UNITED STATES
NUCLEAR WASTE TECHNICAL REVIEW BOARD
2300 Clarendon Boulevard, Suite 1300
Arlington, VA 22201

U.S. Nuclear Waste Technical Review Board
Report to Congress and the Secretary of Energy
December 19, 2003

**Letter to Dr. Margaret S. Y. Chu, Director
Office of Civilian Radioactive Waste Management
U.S. Department of Energy**

An Evaluation of Key Elements in the
U. S. Department of Energy's
Proposed System for Isolating and Containing Radioactive Waste

CP of Alloy 22 in CaCl₂ Brines (No Nitrate)

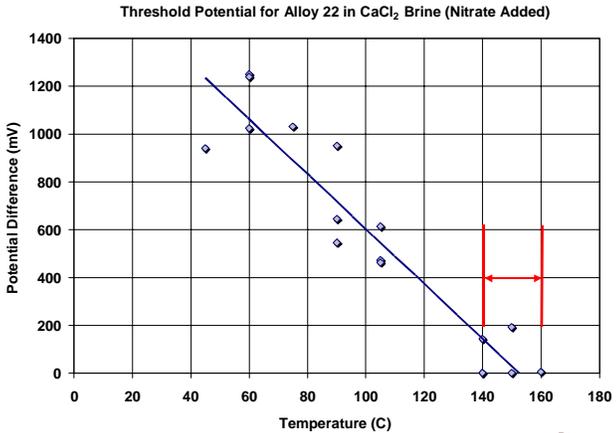
This figure is another overhead from Dr. Farmer’s presentation at the January 28, 2003, Board meeting. (There is an error in the title. Instead of “No Nitrate,” it should read “Nitrate Added.”) Again, localized corrosion is virtually certain to initiate when the Potential Difference falls below 0. For Alloy 22 in a concentrated solution of calcium chloride with nitrate added, the overhead indicates that the Potential Difference is below 0 for temperatures of approximately 150°C and higher.

Critical Temperature for Localized Corrosion in Artificial CaCl₂ Brine with NO₃⁻ Inhibitor

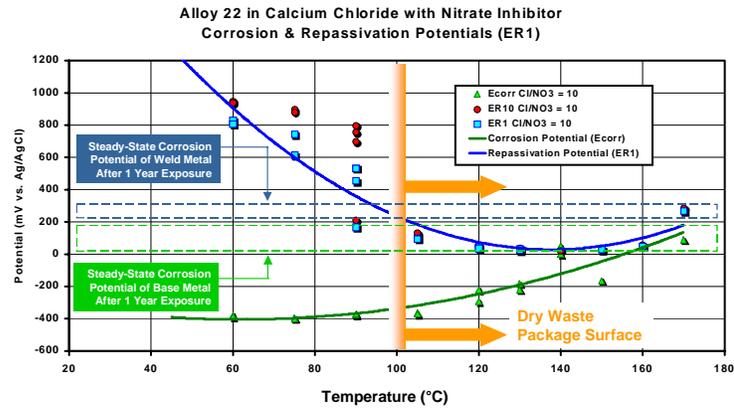
This figure is an overhead from Dr. Farmer's presentation at the May 13, 2003, Board meeting in Washington, D.C. Note the dashed boxes. They indicate that base-metal steady-state corrosion potential moves in a noble (positive) direction with time and that welded-metal corrosion potential moves even farther in that direction with time, indicating increasing susceptibility to crevice corrosion with aging time and in welded structures. Although the overhead appears to state that waste package surfaces are dry above approximately 120°C, deliquescence of salts in the dust on waste package surfaces can cause brines to form at temperatures up to approximately 150°-160°C.

Localized Corrosion of Mill-Annealed Alloy 22

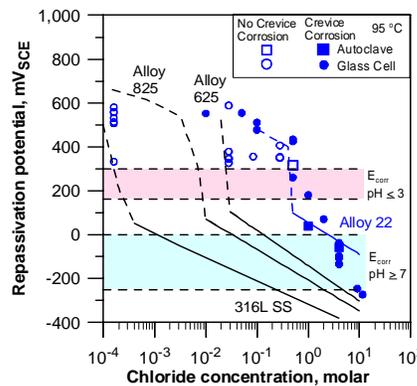
This figure to the right is an overhead from Dr. Cragnolino's presentation at the May 14, 2003, Board meeting in Washington, D.C. Note that Alloy 22 is more resistant to localized corrosion than other nickel-chromium-molybdenum alloys (alloys 625 and 825) and than a nickel-chromium alloy (316 stainless steel).

Effect of Fabrication Processes on Localized Corrosion

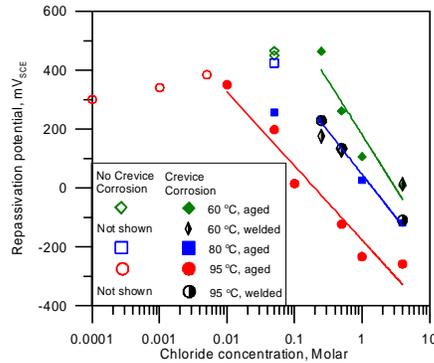
This figure is an overhead from Dr. Cragnolino's presentation at the May 14, 2003, Board meeting. It illustrates the increased susceptibility of welded and thermally aged Alloy 22 in comparison to mill-annealed material.

Effect of Nitrate on Localized Corrosion of Alloy 22

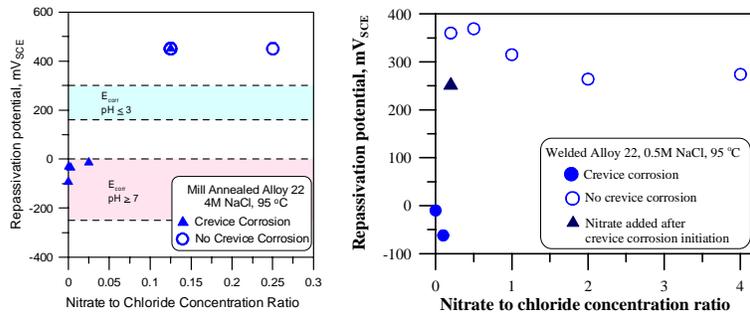
This figure is an overhead from Dr. Cragnolino's presentation at the May 14, 2003, Board meeting. It illustrates the beneficial effect of nitrate on localized corrosion susceptibility of Alloy 22 at 95°C. There is an error in the next-to-last line. Rather than "1.2 for mill-annealed material," it should read "0.12 for mill-annealed material."

Effect of Temperature on Localized Corrosion

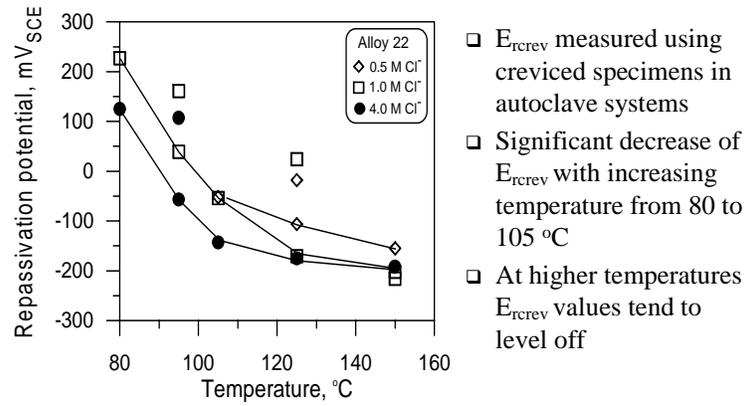
This figure is an overhead from Dr. Cragnolino's presentation at the May 14, 2003, Board meeting. It illustrates how repassivation potential decreases with temperature.
